# Route 5/Virginia Capital Trail

## Pedestrian Safety and Operational Assessment

### Henrico County, Virginia

**July 8, 2016**

# WILLIS CHURCH ROAD AREA

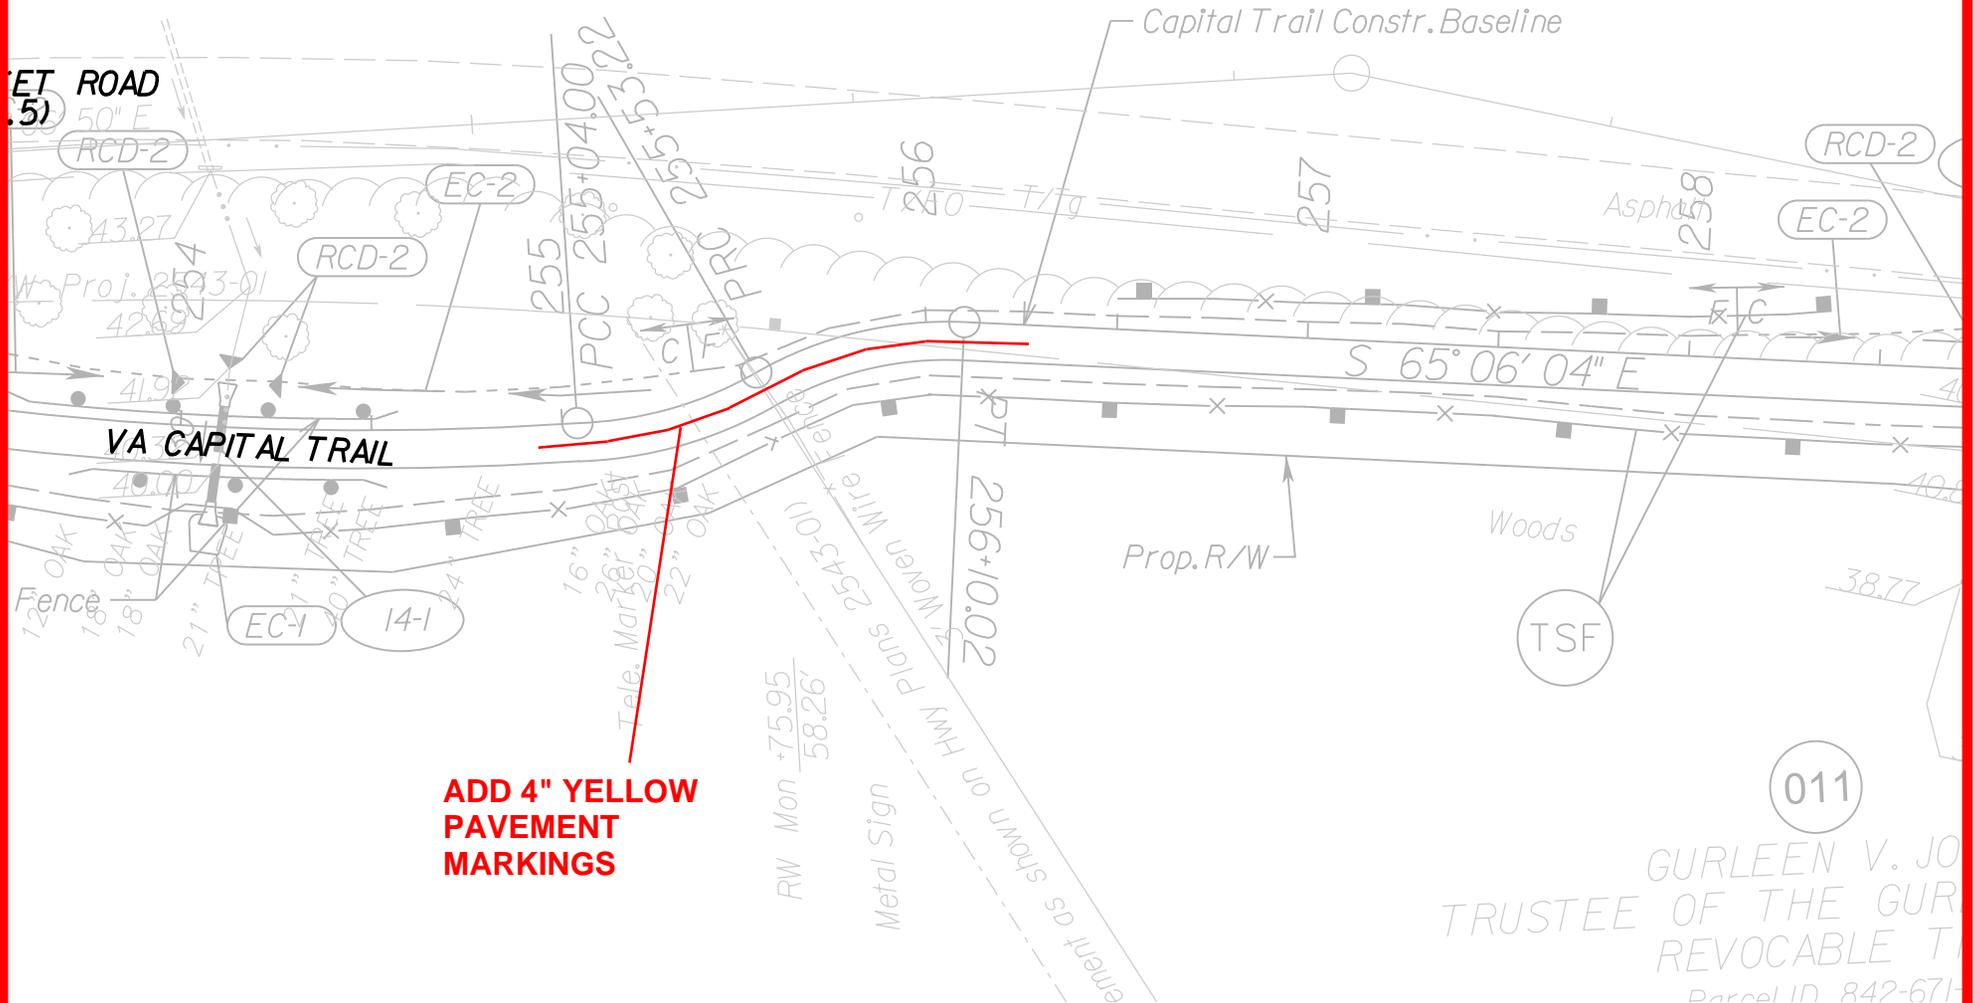
**ADD 4" YELLOW  
PAVEMENT  
MARKINGS**
